PROPOSED TECHNICAL SPECIFICATION CHANGES

MANAGEMENT ORGANIZATION AND TITLES

AUDIT FREQUENCY

POWER AUTHORITY OF THE STATE OF NEW YORK
INDIAN POINT 3 NUCLEAR POWER PLANT
DOCKET NO. 50-286
DPR-64

FIGURE 6.2-1

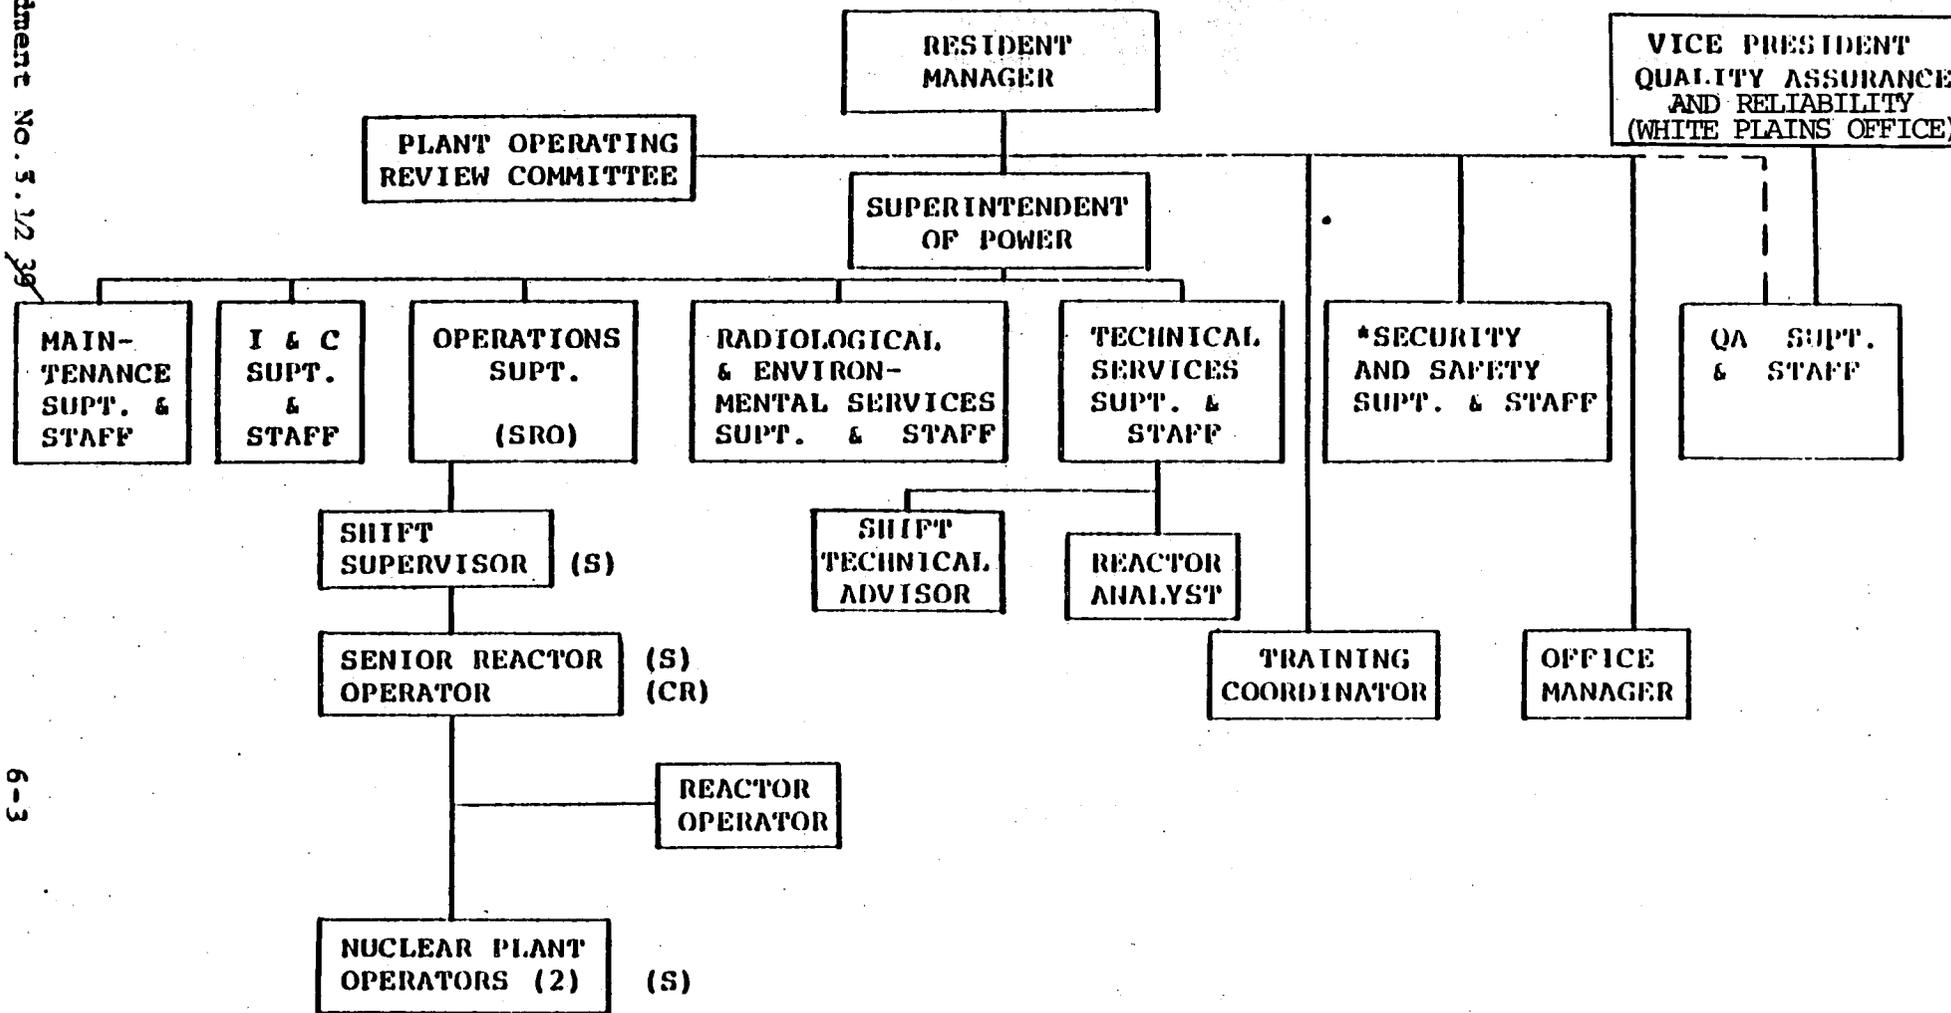
In Figure 6.2-1 of Appendix A, page 6-2, "Procedures and Performance" is replaced by "Quality Assurance and Reliability". Also in this figure, the position entitled "Director of Safety and Fire Protection Procedures and Performance" is renamed as "Director of Safety and Fire Protection." The phrase "which is part of the Quality Assurance and Reliability Department," is added to the sentence denoted by an asterisk. Also in this sentence, "Safety and Fire Protection" has been changed to "the Safety and Fire Protection Division".

FIGURE 5.2-2
 MANAGEMENT ORGANIZATION-OFFSITE ENVIRONMENTAL
 INDIAN POINT 3 NUCLEAR POWER PLANT

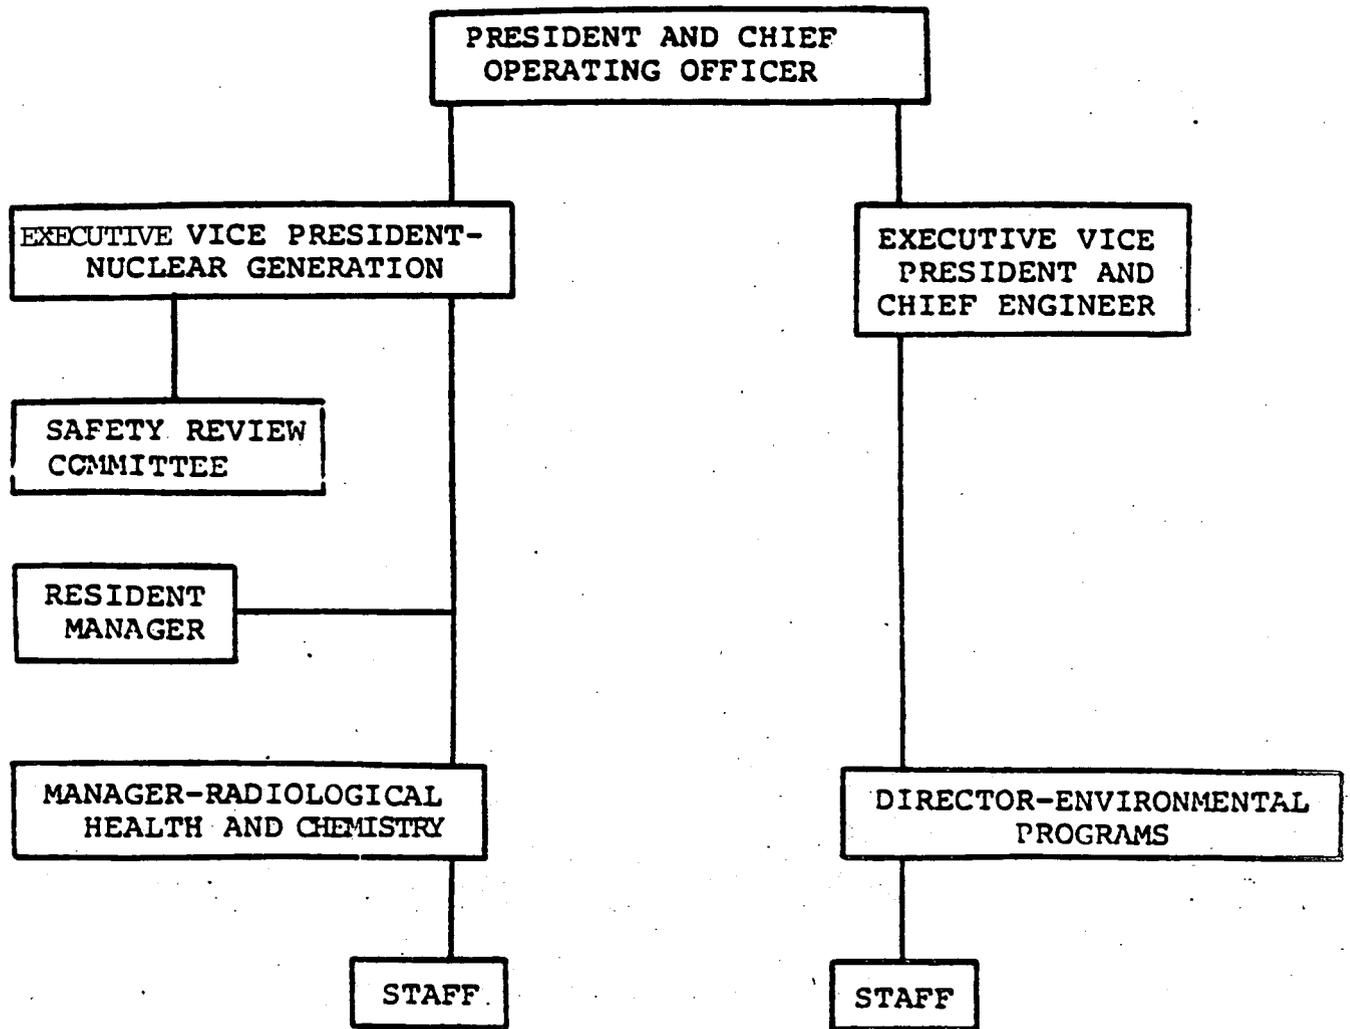
The title of Senior Vice President - Nuclear Generation is changed to Executive Vice President - Nuclear Generation in Appendix B, Figure 5.2-2 (page 5-8) and in Appendix A, Sections 6.1.1 (page 6-1), 6.5.1.6e (page 6-7), 6.5.1.7c (page 6-7), 6.5.1.8 (page 6-8), 6.5.2.8g (page 6-11), 6.5.2.9 (page 6-11), 6.5.2.10 a through c (page 6-12), 6.5.2.11 (page 6-12), 6.6.1b (page 6-12), 6.7.1b (page 6-12), and 6.7.1d (page 6-13).
